CHANGE ORDER NO. 1

OWNER	City of Baxter	DATE	August 13, 2026
CONTRACTOR	RL Larson Excavating, Inc.	SEH No.	BAXTE 184519
ENGINEER	SEH	City No.	4068
Project	2026 Clearwater Road, North Lynndale Area, and Brentwood Circle Street & Utility Improvements

Revised Drawing Nos. 97-98, dated 05/21/2026.

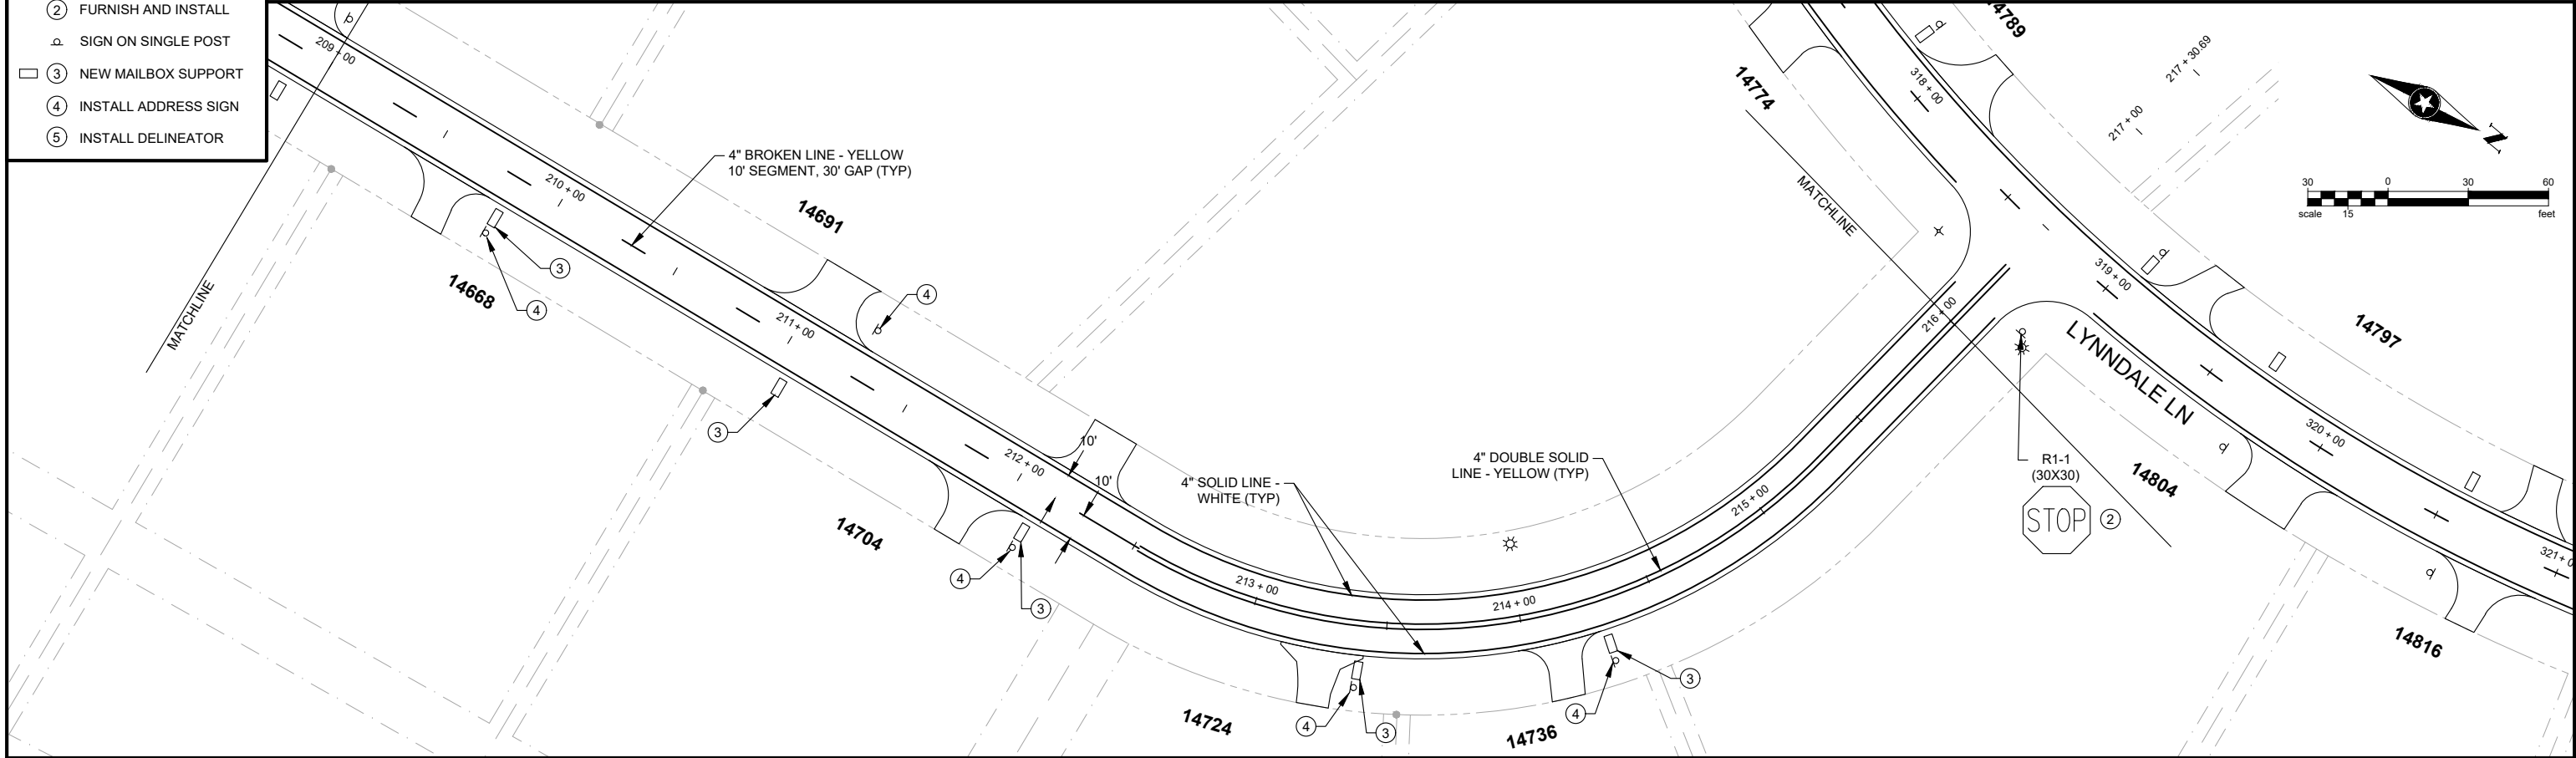
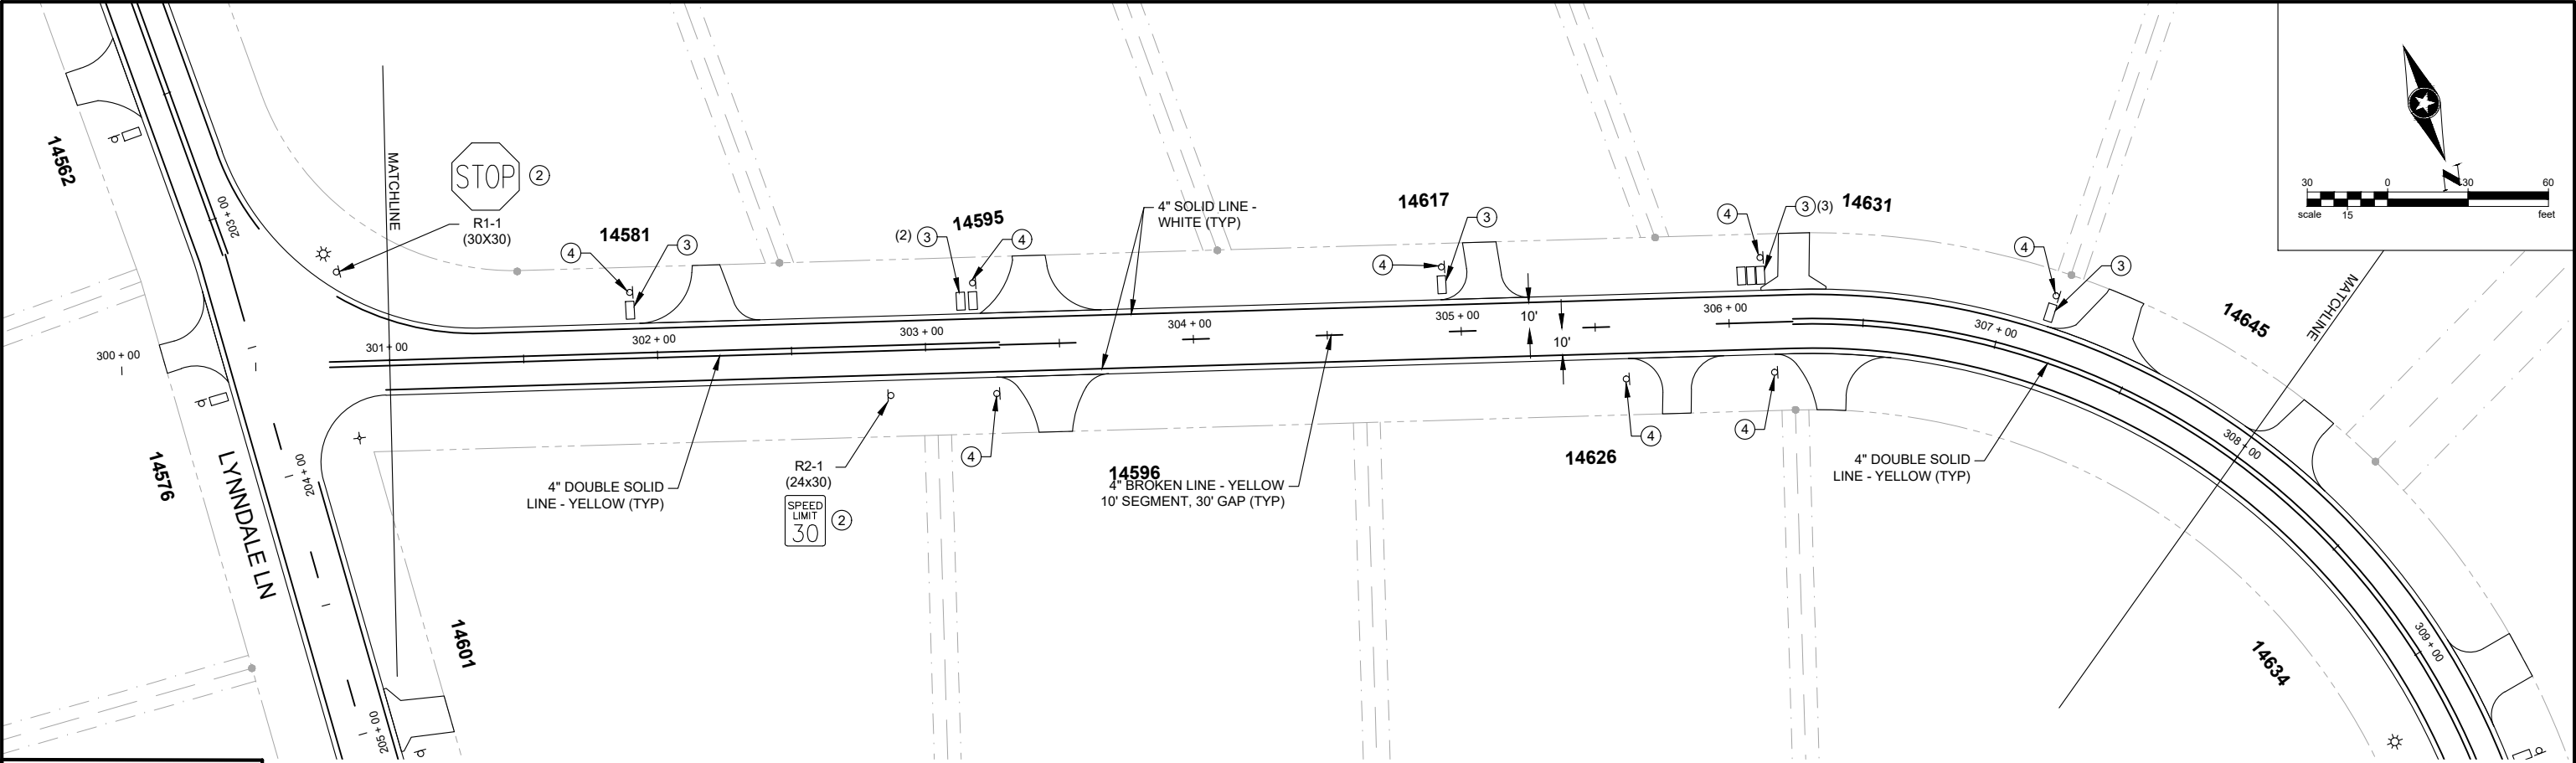
During project meetings, residents noted a desire for methods to reduce traffic speed. On the recent South Forestview project, lanes were striped at 10-foot wide throughout the neighborhood. The striping plans for this project were updated for two road segments, Lynndale Lane and Lynndale Drive, to include striping fog lines to delineate ten-foot lanes. Refer to the attached plan sheets for a depiction of the revised striping layout.

ITEM	DESCRIPTION	UNIT	QUANTITY	UNIT COST	AMOUNT
75A	4" SOLID LINE PAINT	LIN FT	9,868.00	\$0.30	\$2,960.40
TOTAL					\$2,960.40
